# Extension proposal for P802.1CBdb chapter “Stream identification”

Questions related to  
IEEE802.1Q chapter “Flow classification and metering”  
extension proposal for  
P802.1CBdb chapter “Stream identification”

Günter Steindl

Siemens AG

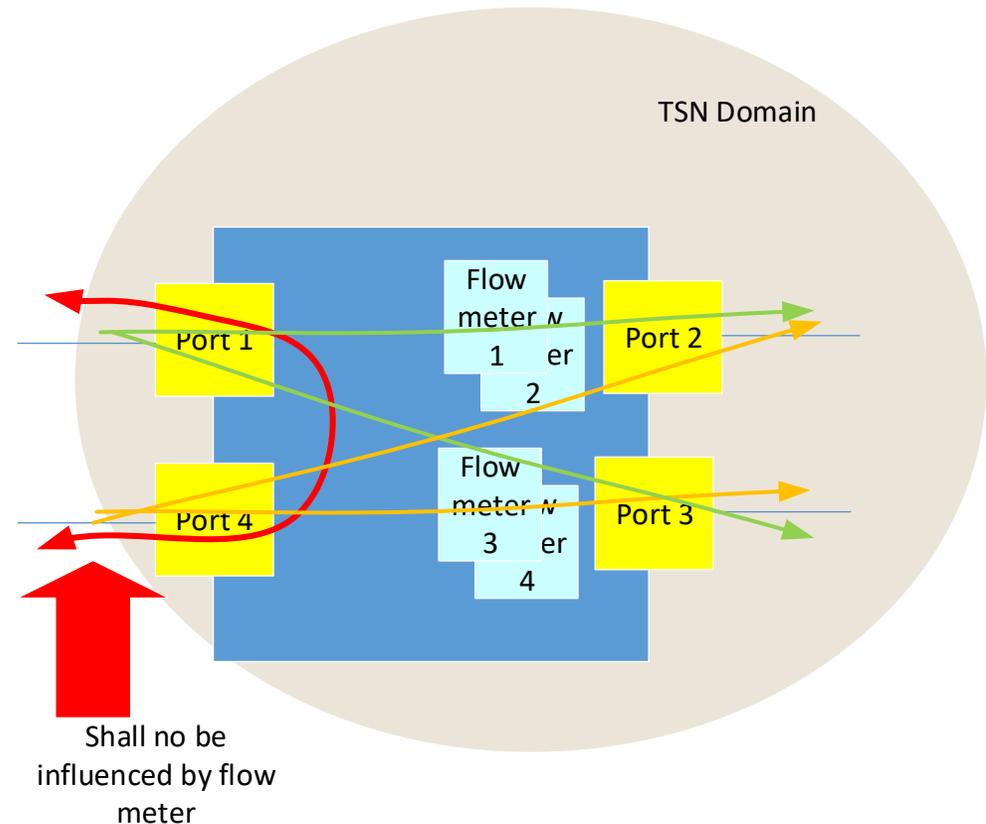
- **Flow meter 1** (green arrow) only measures the frames from port 1 to port 2 and **flow meter 3** (green arrow) only measures the frames from port 1 to port 3
- **Flow meter 2** (orange arrow) only measures the frames from port 4 to port 2 and **flow meter 4** (green arrow) only measures the frames from port 4 to port 3
- Frames from port 1 to port 4 (red arrow) **shall not be** influenced by flow meters

-> **How can this be solved?**

Add another line to P802.1CBdb Table 6-1 for TSN domain protection

Name: <Port number-based stream identification>

Active/Passive: Seems not applicable (pure identification for metering)

Examines: Reception port number, {group address, unicast address}, transmission port number

Overwrites: None

Reference: 6.9, 9.1.8 – needs to be written
